**FILE** STP-0000-00(844) Gwinnett County **OFFICE** Preconstruction  
P.I. No. 0000844  
*CWH* **DATE** August 23, 2001  
**FROM** C. Wayne Hutto, Assistant Director of Preconstruction  
**TO** SEE DISTRIBUTION

**SUBJECT PROJECT CONCEPT REPORT APPROVAL**

**FILE:** STP-0000-00(844) Gwinnett  
P.I. Number 0000844

**SUBJECT:** **CONCEPT REPORT**

DESIGNER		DATE									
REVISIONS		BY									
WOLFEIN & ASSOCIATES, INC. 5310 ARCADIO PARKWAY HOUSTON, TEXAS 77055 (713) 241-1111											
BEHAVIORAL & ASSOCIATES, INC. 5310 ARCADIO PARKWAY HOUSTON, TEXAS 77055 (713) 241-1111											
BEAVER RUIN ROAD TYPICAL SECTIONS BEAVER RUIN RD @ U.S. 29

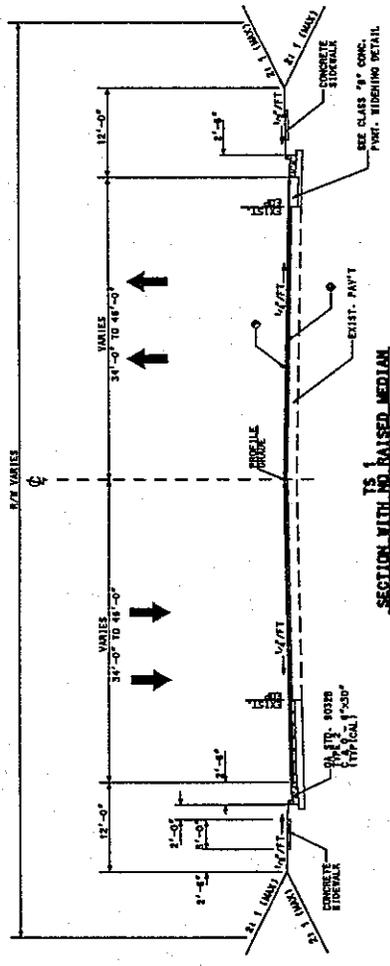
2. The 1125 tons of 1.5 inches of Asphalt Concrete Superpave shown in the cost estimate is not adequate to surface the existing pavement and proposed widening as shown on the typical sections.
